## **DNJ ADDITION TO MOBILE SUBDIVISION**

APPLICATION NUMBER 2 DATE February 16, 2017

REQUEST Subdivision

# DETAIL SITE PLAN

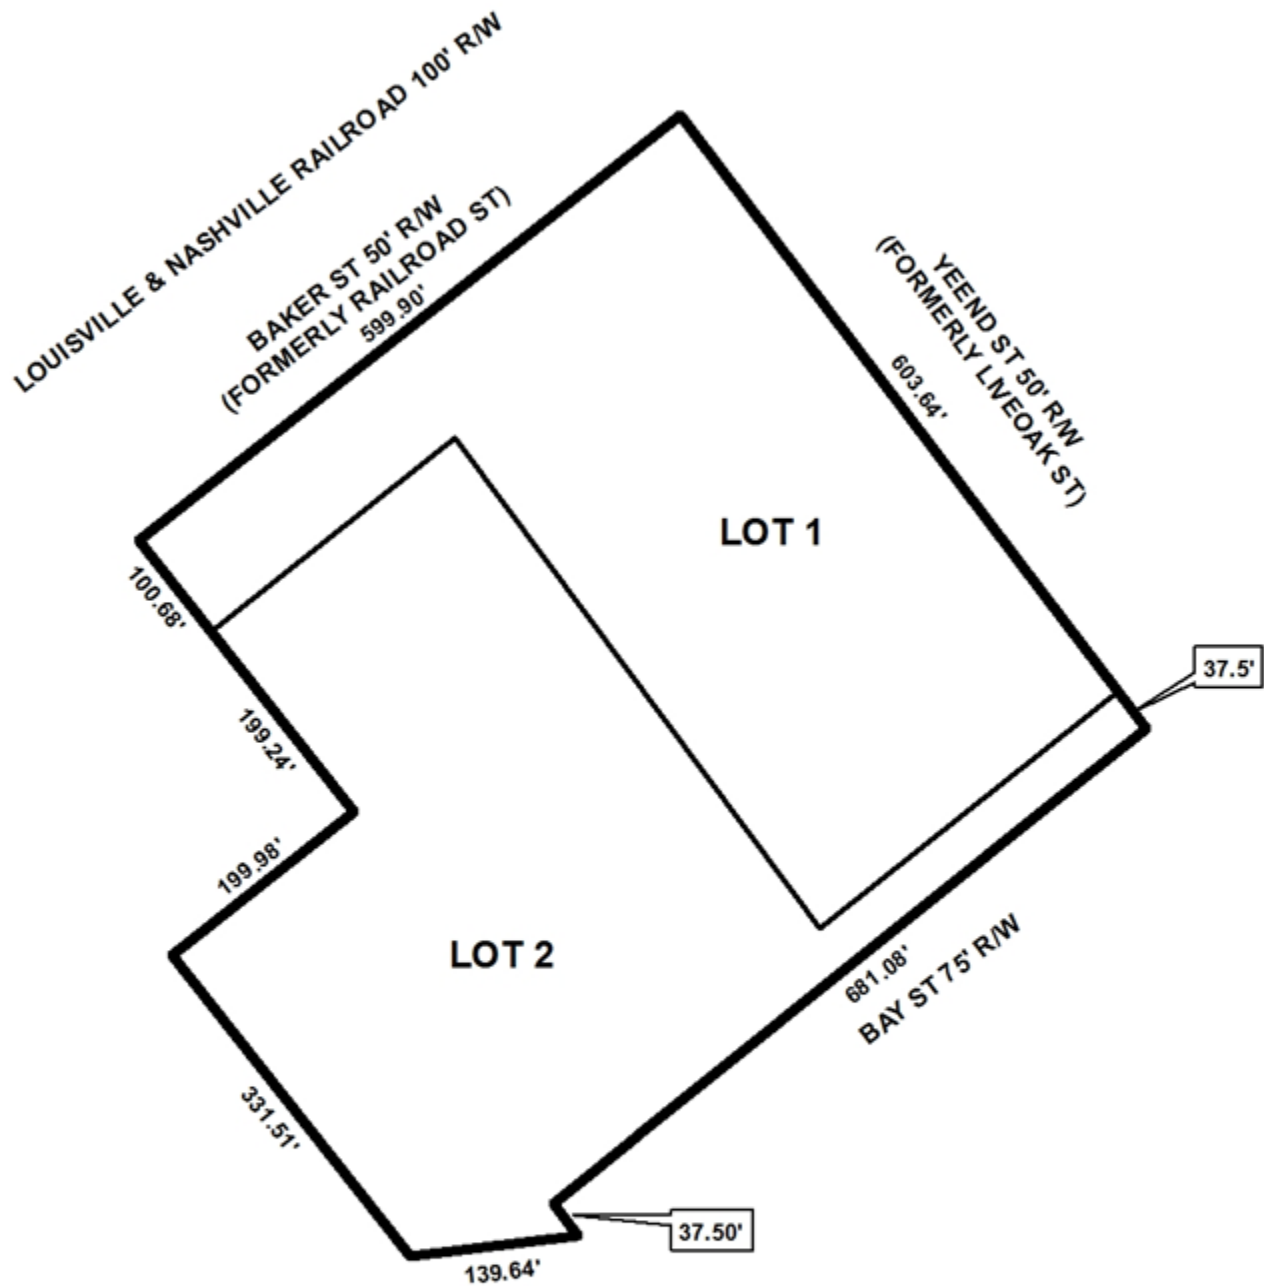
- B. Dedicate the corner radius (25' minimum or as approved by the City Engineer and Traffic Engineer) at the northern corner of LOT 1 (corner of Baker Street and Yeend Street).

- G. The existing drainage ditch that runs through LOT 1 and LOT 2 needs to be contained in a PUBLIC (Dedicated to the City of Mobile) drainage EASEMENT; the width and alignment of the easement shall be coordinated with, and approved by, the City Engineer. Additional width may be required to allow vehicular and equipment access.

be revised to illustrate the minimum building setback line along Yeend Street as measured 65' from the centerline of Yeend Street (40' for possible widening and 25' for the setback from any future right-of-way after widening). The plat should also be revised to illustrate a 25' minimum building setback line along Baker Street as measured from the current right-of-way line. The plat should also be revised to illustrate the dedication of a 25' corner radius at the intersection of Baker Street and Yeend Street.

- 1) revision of the plat to illustrate a minimum building setback line of 65' as measured from the centerline of Yeend Street and the proposed Royal Street South major street;

- 2) revision of the plat to illustrate a 25' minimum building setback line along Baker Street as measured from the current right-of-way line;
- 3) revision of the plat to provide a 25' radius corner dedication at the intersection of Baker Street and Yeend Street;

*The revised plat indicates the minimum building setback line along Yeend Street as being 65' from the centerline of Yeend Street and the proposed Royal Street South major street, and as being 25' from the current Baker Street right-of-way. A 25' corner radius dedication is indicated at the corner of Baker Street and Yeend Street*

*Due to the fact that the subdivision is now two lots and Lot 2 currently only has a curb cut onto the now-vacated Bay Street right-of-way and crosses onto Alabama Power property, and since Lot 2 would be a flag lot and the only public street access point would be at the terminus of the "pole" onto Yeend Street and the proposed South Royal Street major street, the Traffic Engineering comments have been revised to allow Lot 2 one curb cut onto Yeend Street, with the size, location and design to be approved by Traffic Engineering and conform to AASHTO standards. Therefore, Note 12 on the plat should be revised to reflect the revised Traffic Engineering comments limiting Lot 1 to its existing curb cuts and Lot 2 to one curb cut.*

*As proposed Lot 2 would be a flag lot, a waiver of Section V.D.1. of the Subdivision Regulations would be required for its shape. As the site is within an industrial area where other irregularly-shaped lots have been approved by the Commission, a waiver would seem in order. And since the lot would exceed the maximum depth-to-width ratio of Section V.D.3., a waiver of that section would be required and would seem in order as other industrial sites have been approved by the Commission with such configurations.*

- 1) retention of the 40' minimum building setback line along Yeend Street as measured 65' from the centerline of Yeend Street and the proposed Royal Street South major street;*

- 2) retention of the 25' minimum building setback line along Baker Street as measured from the current right-of-way line;*
- 3) retention of the 25' radius corner dedication at the intersection of Baker Street and Yeend Street;*

- 4) placement of a note on the Final Plat stating that Lot 1 is limited to its existing curb cuts and Lot 2 is limited to one curb cut, with size, location and design to be approved by Traffic Engineering and conform to AASHTO standards;*
